MONTGOMERY COUNTY PLANNING DEPARTMENT
THE MARYLAND-NATIONAL CAPITAL PARK AND PLANNING COMMISSION

REVIEW TYPE: Preliminary Plan of Subdivision

PROJECT NAME: Snow Hill Farm

CASE #: 120070570

Figure 2: Preliminary Plan

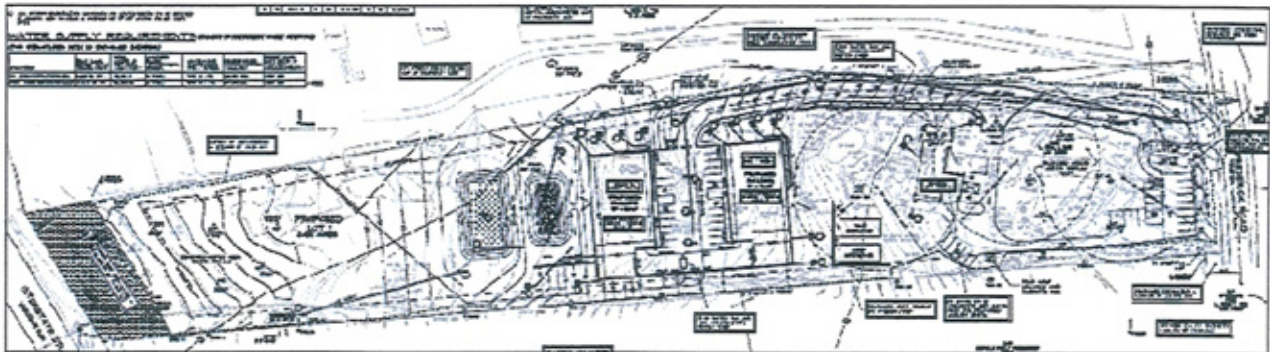
The Applicant proposes to record the existing parcel into one lot approximately 6.45 acres in size. The proposed lot would have 3,100 square feet of retail and 2,500 square feet of storage for a nursery/garden center, and 20,323 square feet of farm machinery storage and service space. Access to the lot and structures will be provided from Frederick Road via a private driveway. The existing house will be converted into the sales area for the nursery/garden center. The proposed nursery/garden center will be served by a private well and a private standard septic system.

Access to the Subject Property is provided via a private driveway from Frederick Road (MD 355). SHA will require the construction of an exclusive northbound MD 355 left turn lane and a southbound MD 355 deceleration lane and acceleration lane at the MD 355/Site Access Drive intersection. Staff finds that the proposed access point is adequate to accommodate the site-generated traffic. Staff has also reviewed the proposed internal traffic/pedestrian circulation systems shown on the preliminary plan and finds them to be adequate.

Section 1607(c) of the Natural Resources Article, MD Ann. Code identifies certain individual trees as high priority for retention and protection. If a forest conservation plan cannot be altered to protect these trees, the Applicant is required to demonstrate that it qualifies for a variance in accordance with Section 22A-21 of the Montgomery County Code to remove them. In general, the law requires the retention and protection of all trees that measure 30" DBH and greater; trees that are 75% or greater than the diameter of the county champion for that species; and rare, threatened and endangered species. Since this project will require the removal of two trees greater than 30 inches DBH, a variance is required. The trees that are requested to be removed are identified on the Preliminary Forest Conservation Plan as tree #104 and tree #118. Tree

#104 is located in the center of the proposed drive on the north side of the property and is a 31” DBH Norway maple (*Acer platanoides*). Tree #118, located in the center of the property, is a 33” honey locust (*Gleditsia triacanthos*).

The Norway maple, an invasive species, will need to be removed to accommodate the proposed driveway from 355. The proposed display area and narrow width of the lot doesn’t leave the Applicant with enough room to relocate the driveway in a way that will not impact the Norway maple. The honey locust is located in an area near the proposed nursery that will be used for storage and display purposes, which will likely impact the CRZ. Therefore, the site layout and design necessitates the removal of the 31” DBH Norway maple (*Acer platanoides*) and the 33” honey locust (*Gleditsia triacanthos*) since the trees will likely become hazardous following the removal of the CRZ and the proposed grading for the proposed buildings.

- 1) Total development under the subject preliminary plan is limited to one lot for 25,922 square feet of Rural Service (RS) permitted uses, which is comprised of 3,100 square feet of retail space for nursery, 2,500 square feet of storage space for the nursery, and 20,322 square feet of a farm machinery/service area.

- 2) The applicant must provide for pavement marking and signal timing modifications at the intersection of MD 355 and MD 121 subject to the State Highway Administration's approval. The proposed pavement marking is to provide an exclusive left-turn lane and a shared through/right-turn lane on each approach of MD 121. This improvement must be complete prior to obtaining a building permit.

- 4) The Applicant must provide an 8-foot-wide shared use path with a 5-foot-wide landscape panel along the entire length of the property's frontage on MD 355.

- 7) The Applicant must dedicate 40 feet of right-of-way from the centerline of Frederick Road (MD 355) along the property frontage as shown on the preliminary plan.

- 8) The Applicant must dedicate 75 feet of right-of-way along the property frontage of Interstate 270 as shown on the plan.
- 9) The Applicant must satisfy provisions for access and improvements as required by the Maryland State Highway Administration (MDSHA), and including construction of the 8-foot-wide shared use path, prior to issuance of access permits.
